Access Compliance Report

Public Rights-of-Way

(Curb Ramps)

Intersection ID: 50119	Main Street: PARK_SOUTH_STATION_BV	Cross Street: PARK ROYAL_AV	Location: NE
ADA ID: E3E01E805CFB	Ramp Type: Perp	Initial Pass/Fail: Fail	Overall Compliance: No
Severity Score: 22.5			
Codes/Mitigation Info/Possible Solution		Field Measurements/Component Compliance

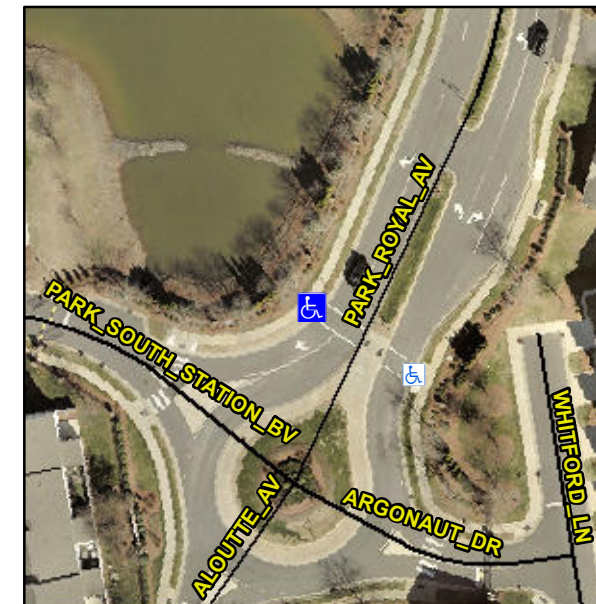
R304.5.1, R304.2.2, R304.5.3

Compliance	Description	Data	Compliance	Description	Data
N/A	Ramp Length (in)	46.0	No	Ramp Slope (%)	8.8
No	Ramp Width (in)	45.5	No	Ramp XSlope (%)	3.3
N/A	Flare Type LT	N/A	N/A	Flare Type RT	N/A
N/A	Flare Slope LT (%)	N/A	N/A	Flare Slope RT (%)	N/A
N/A	Flare Traversable LT?	N/A	N/A	Flare Traversable RT?	N/A
N/A	Landing Length (in)	N/A	N/A	DWS Provided?	N/A
N/A	Landing Width (in)	N/A	N/A	DWS Contrast?	N/A
N/A	Landing Slope (%)	N/A	N/A	DWS Length (in)	N/A
N/A	Landing X Slope (%)	N/A	N/A	DWS Full Width?	N/A
N/A	Landing Curb? (Y/N)	N/A	N/A	DWS Offset (in)	N/A
N/A	Shared Landing?	N/A			
N/A	Gutter Ponding?	N/A	N/A	Gutter Slope (%)	N/A
N/A	Gutter Lip Ht (in)	N/A	N/A	Gutter X Slope (%)	N/A
N/A	Painted X Walk1?	Yes	N/A	Painted X Walk2?	N/A
	X Walk 1 Direction	To SE		X Walk 2 Direction	N/A
N/A	X Walk 1 Width (in)	110.0	N/A	X Walk 2 Width (in)	N/A
	X Walk 1 Slope (%)	6.6		X Walk 2 Slope (%)	N/A
	X Walk 1 X Slope (%)	2.1		X Walk 2 X Slope (%)	N/A

Remove & Replace Entire Ramp.
